## Review of Tube R2C5 in Steam

Generator 24  
Phase settings between 1997 and 2000

## Review of Indian Point

**Figure 7** Contour of the crack in tube R2C5 in SG24 using the 1997 data from the mid-range plus-point probe.

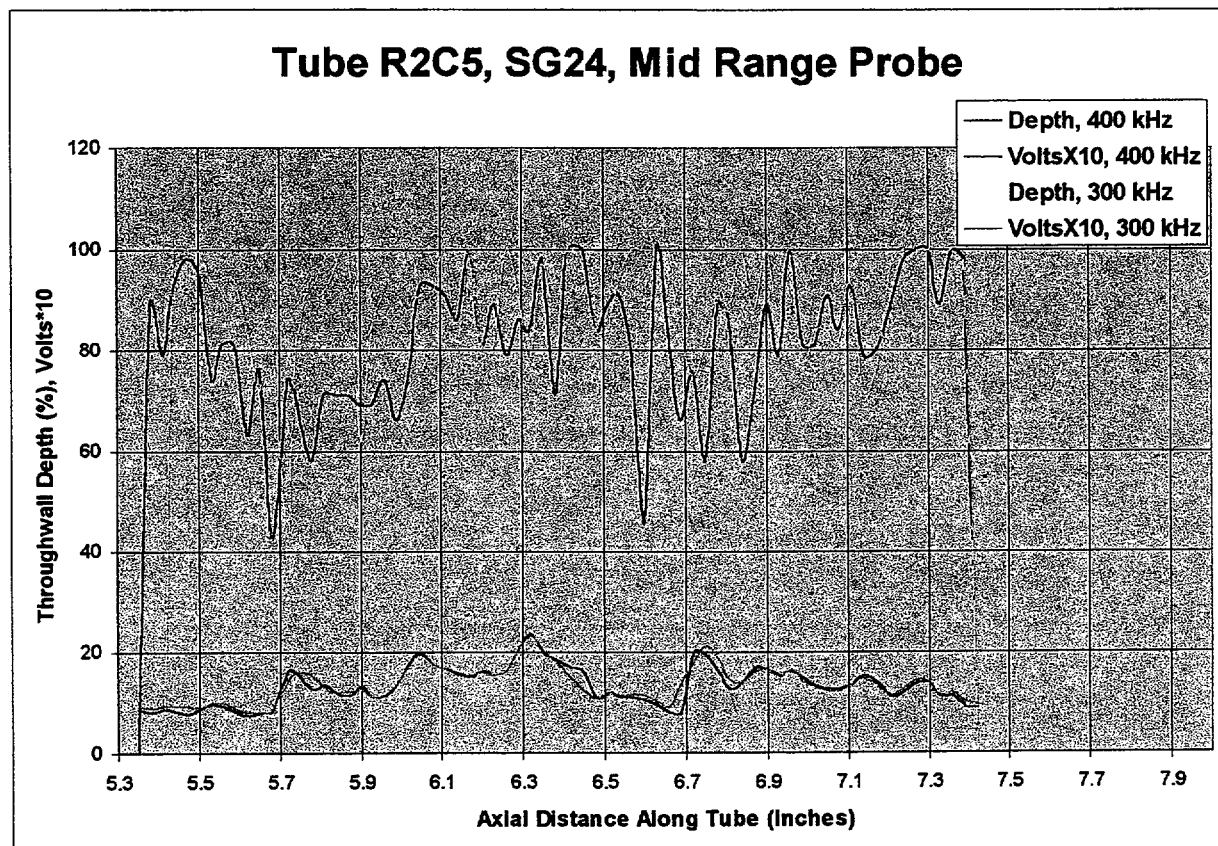
The indication has been profiled for both frequencies, as is shown in Figure 7. The 400kHz profile is probably slightly more accurate than the 300 kHz profile. Neither is very accurate, and until the defect voltage increases above 1.2-volts, there is considerable error. This can be contrasted to the 0.4-volt threshold for the high-frequency probe. No attempt has been made to

**Figure 8** C-scan of tube r2c5 of steam generator 24 using the circumferential line filter.

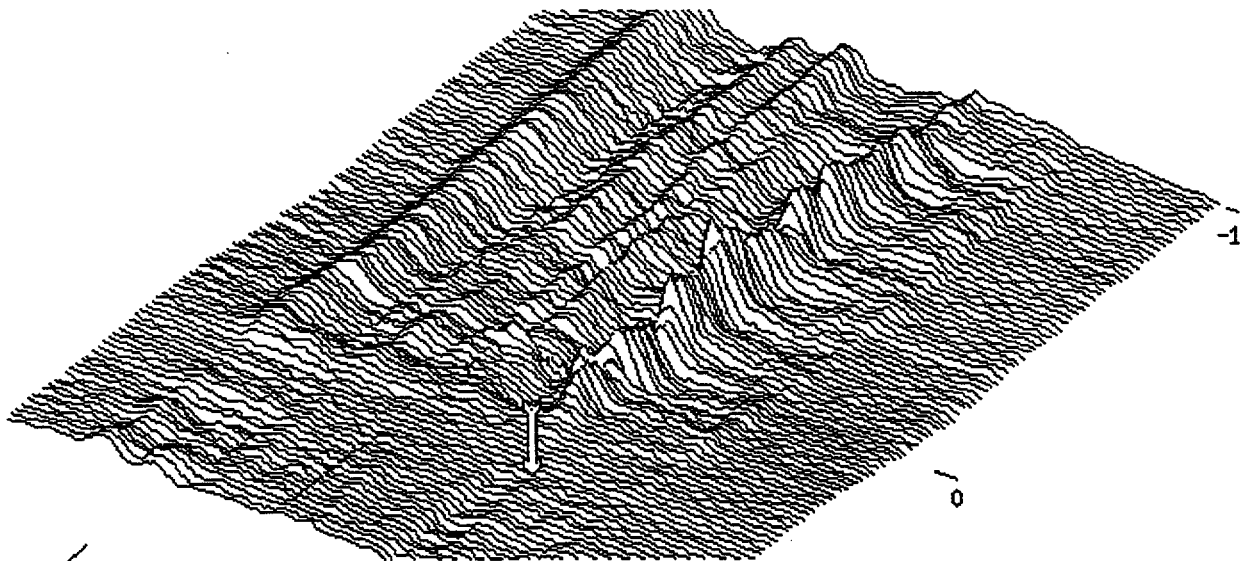
Westinghouse discourages the use of filters in general since they throw away some of the signal that may contain a defect. In Figure 8 we show a C-scan of the R2C5 using the circumferential line filter. We are subtracting the signal from a single circumferential line set at the location of the arrow. The defect is easier to see at this location. The signal from the ridges cancels out near the location that we set the line filter, but, due to the variation of the axial ridges with distance along

the tube, it reappears a short distance away. However, the defect signal is displayed in a form easier to recognize. This scan can be compared to the scan in Figure 2 with the line filter off. This method can be used as a tool to help the analyst, but it also does not do as good a job of eliminating the noise signals as the high-frequency probe. It is hard to use the filters and do a profile of the tube since the filters turns off when the next line scan button is pushed.
